8K and 16K Microwire EEPROM Enhancements

AN903

FIGURE 1: RECOMMENDED MIGRATION PATHS

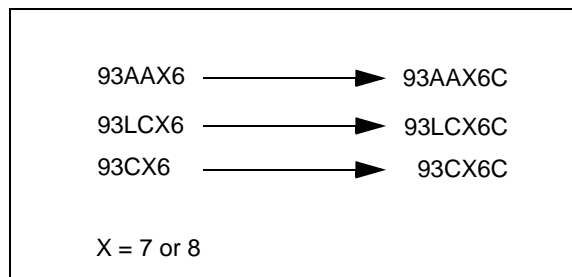
Because of this change in nominal voltage detect, applications that used Group 1 'C' devices, and have a requirement to operate below 4.5V, should be converted to Group 4 'LC' devices.

FIGURE 2: WRITE TIMING

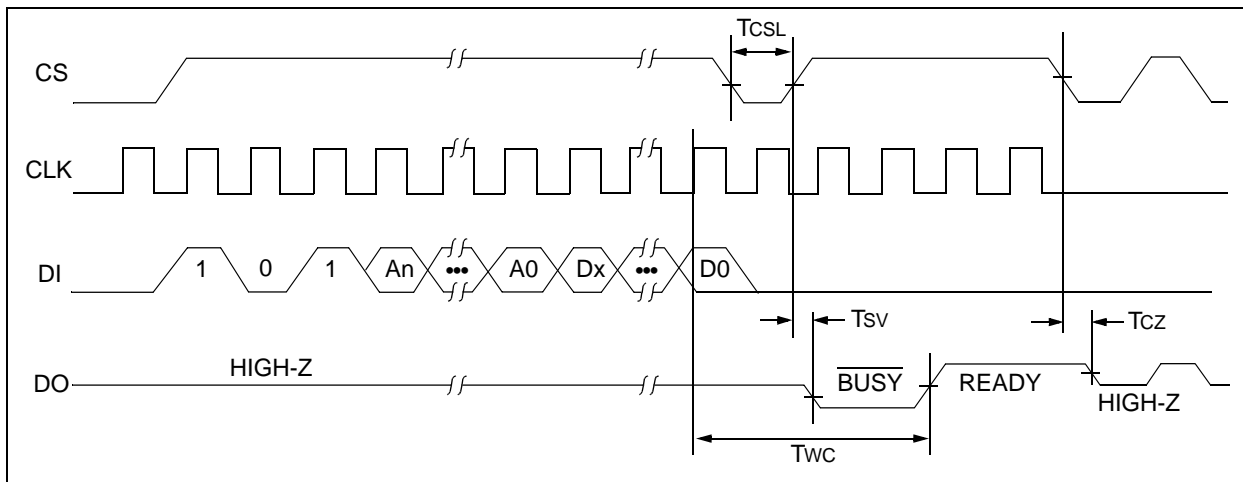
Ready/Busy operations have not changed either. However, it is important to note that CS must be toggled (H-L-H) after the write cycle has been initiated and before the write cycle is complete in order to see transitions on the DO pin. If the CS pin has been toggled and the write cycle has been completed, the DO line will remain in the Ready (Logic '1') state until a valid Start command is given, at which point Ready/Busy operations have been reset. Ready/Busy operations are illustrated in Figure 2.
